**PROJECT**  
**Camden Town Hall Tenant Fitout**

**TITLE**  
**PROPOSED SECOND FLOOR PLAN**

**DRAWING NUMBER**  
**242931-PUR-02-02-DR-A-9203**

**I** **PROPOSED SECOND FLOOR LEVEL PLAN**  
**9202** **1:200 @ A1**

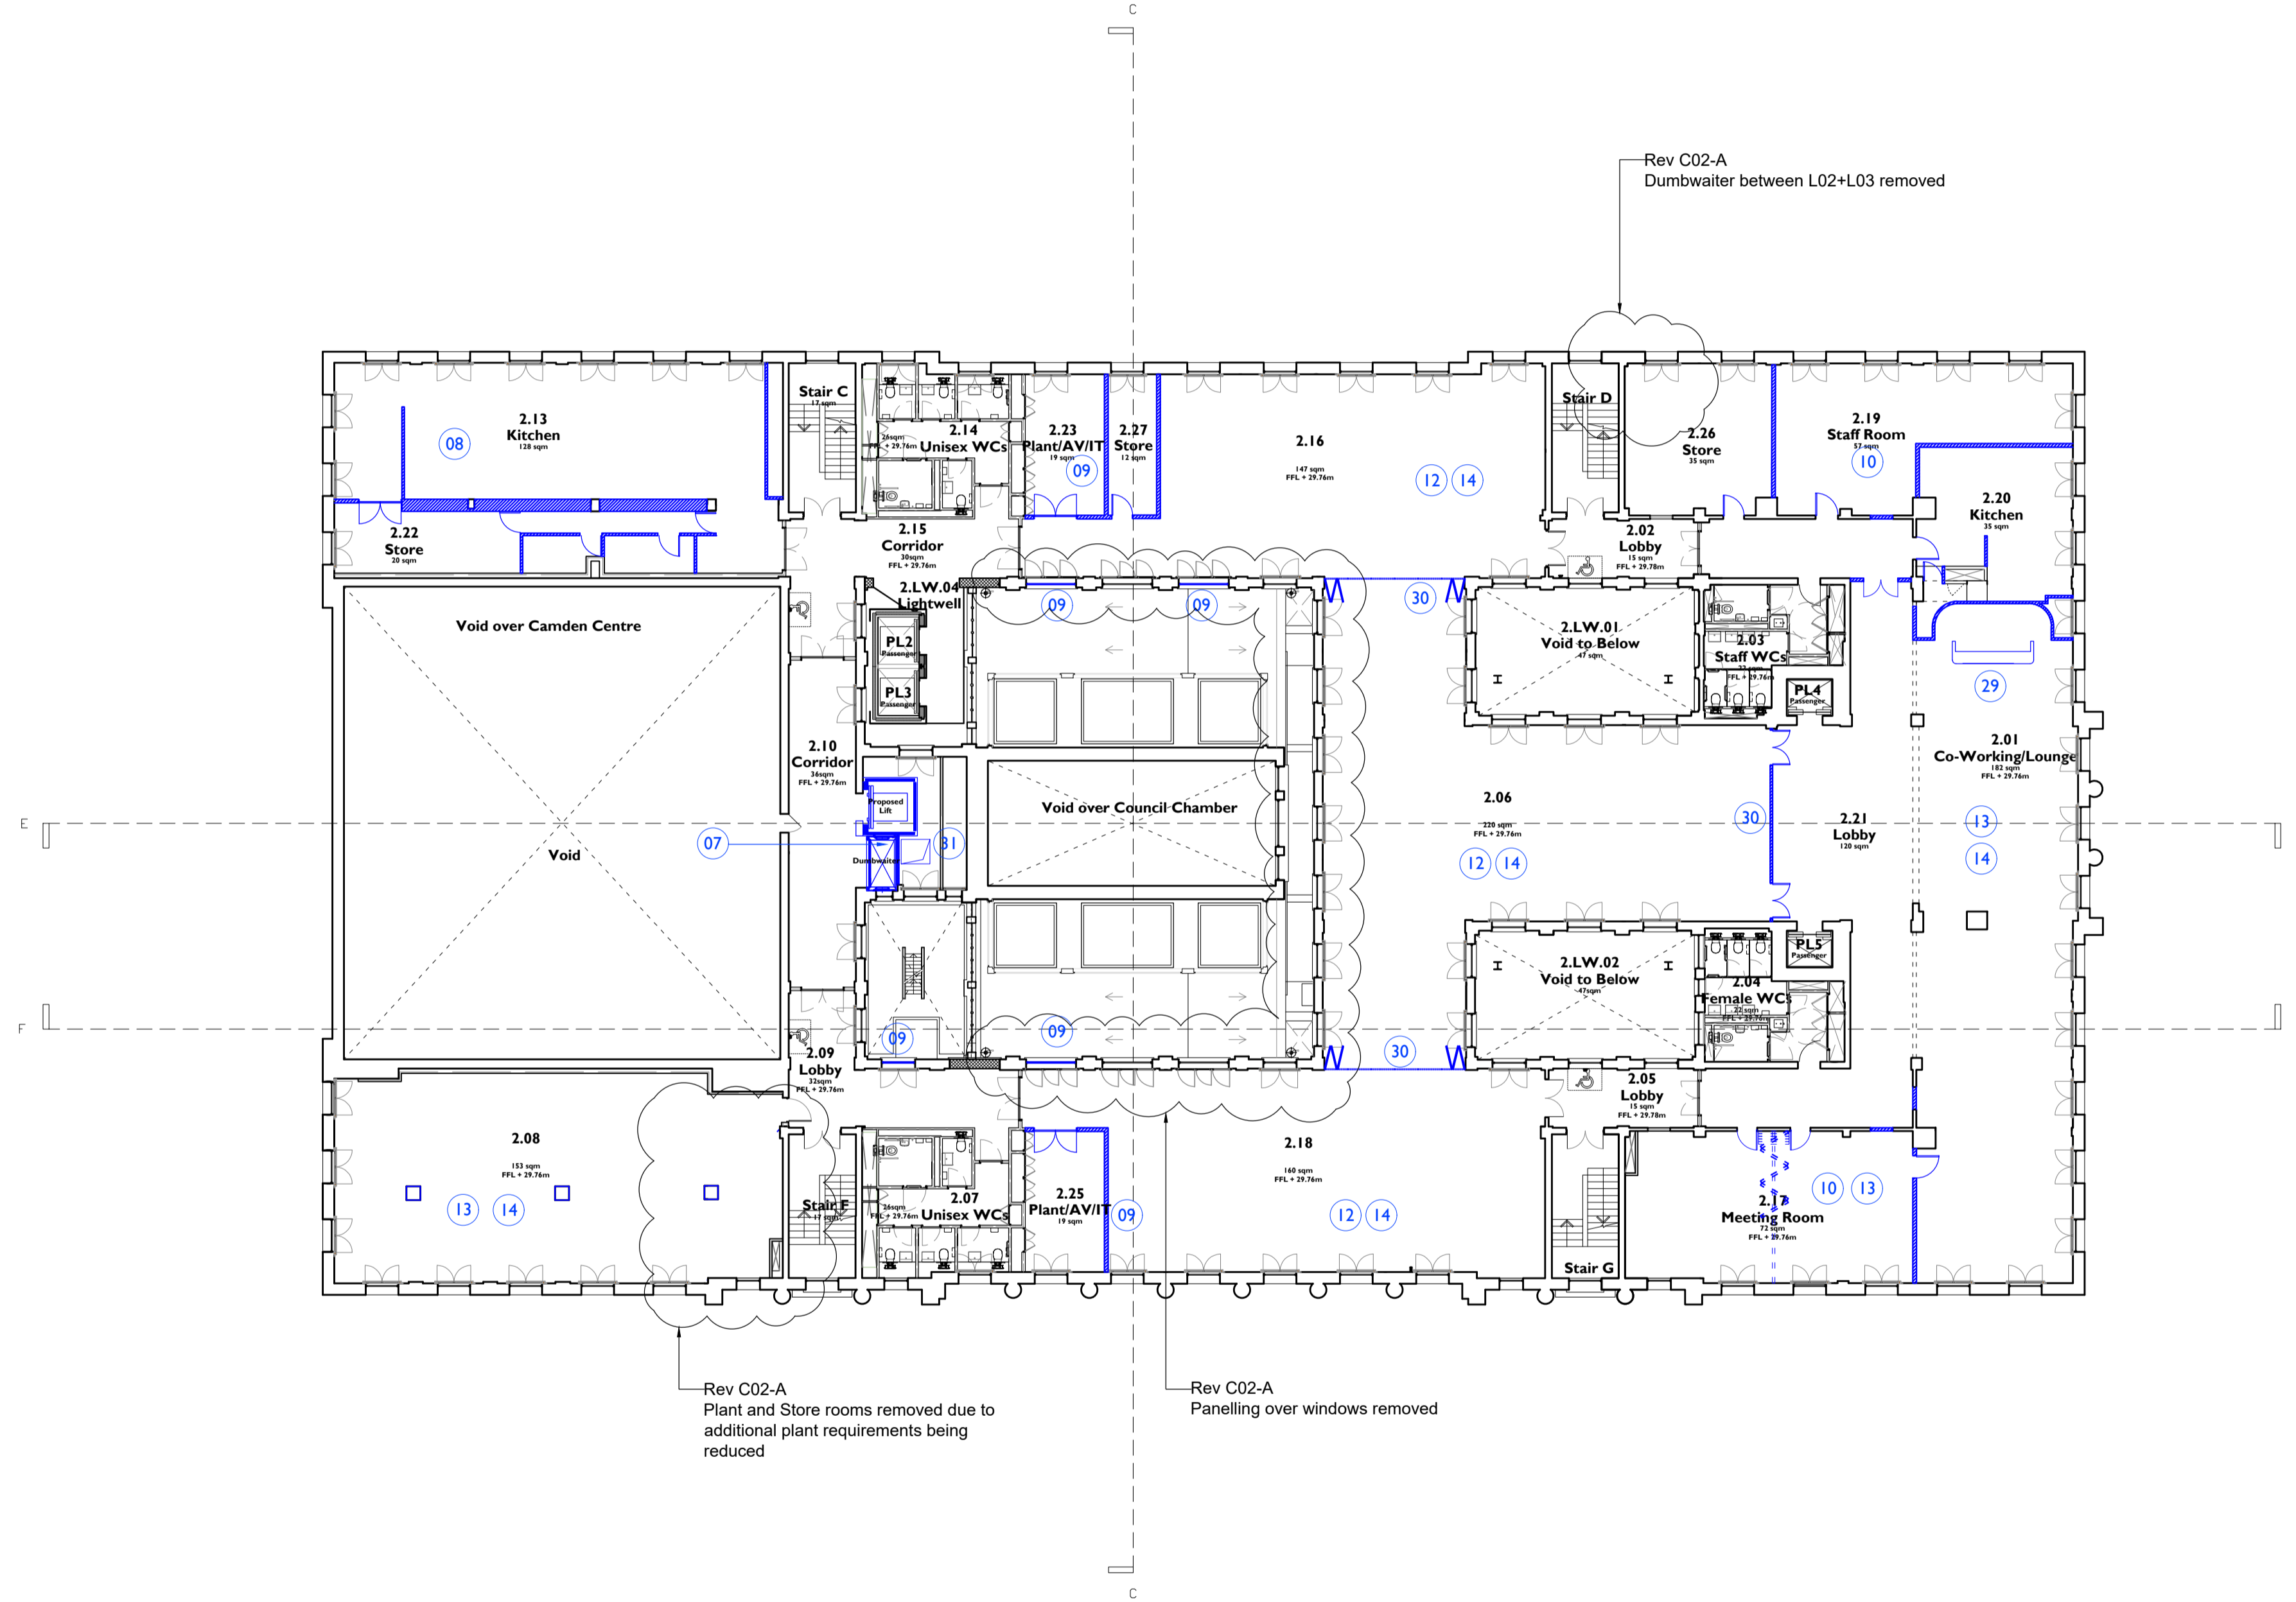
Rev C02-A  
 Plant and Store rooms removed due to additional plant requirements being reduced

Rev C02-A  
 Panelling over windows removed

Rev C02-A  
 Dumbwaiter between L02+L03 removed
